**PLANNED UNIT DEVELOPMENT &
SUBDIVISION STAFF REPORT**

Date: September 4, 2003

Accelerated Technology, Inc.

Cottage Hill Executive Park Subdivision,
Resubdivision of Lots 25, 26 and 27, Resubdivision of
Lot 1

SUBDIVISION PLAT

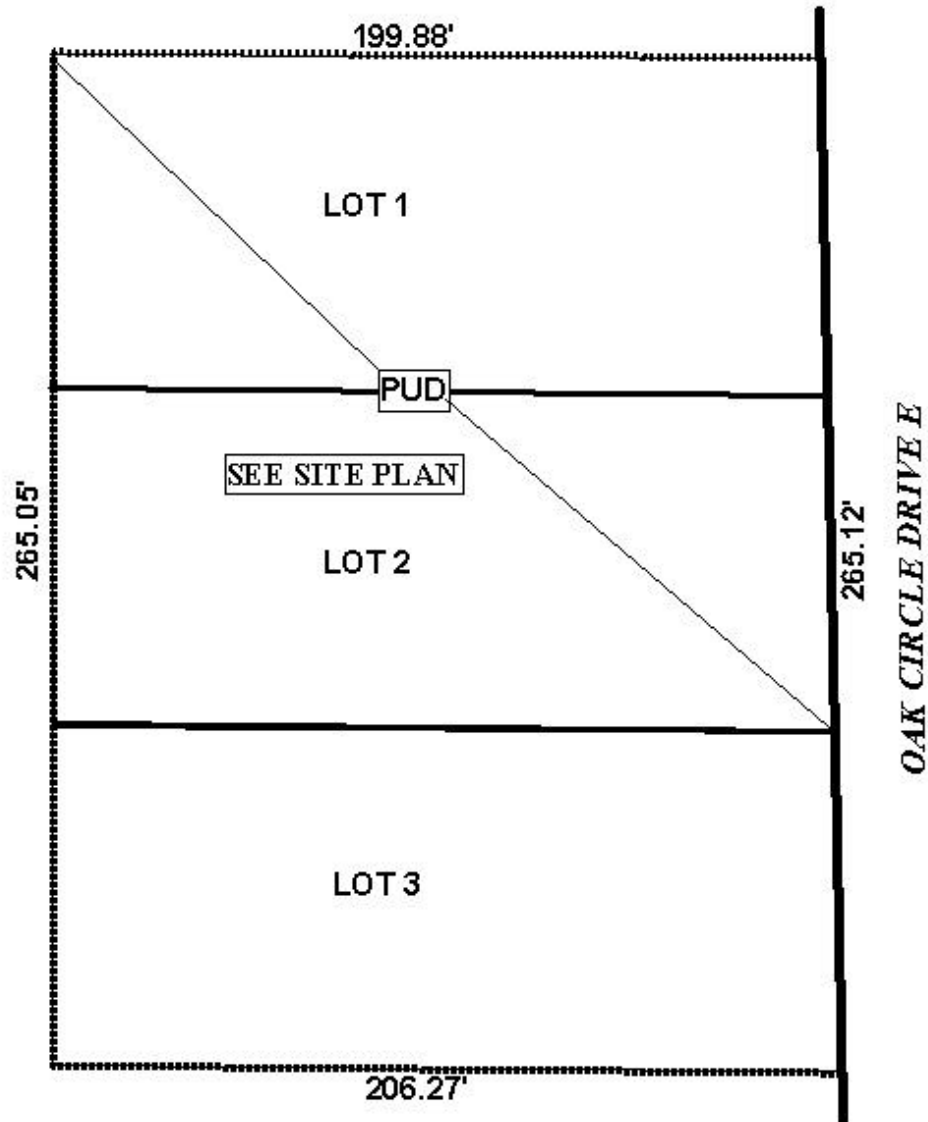
Preservation (removal to be authorized by Mobile
Planning Commission) status be given to the Live Oaks that are on Lot 3 (a 69" Live Oak on
the northwest corner, and an 80" Live Oak on the east side); all work on the above mentioned
trees and all work within the drip line is to be coordinated with Urban Forestry.

Subdivision: The plat meets the minimum requirements of the Subdivision Regulations and is recommended for Tentative Approval subject to the following conditions: 1) placement of a note on the final plat stating that Preservation (removal to be authorized by Mobile Planning Commission) status be is given to the Live Oaks that are on Lot 3 (a 69" Live Oak on the northwest corner, and an 80" Live Oak on the east side); all work on the above mentioned trees and all work within the drip line is to be coordinated with Urban Forestry.
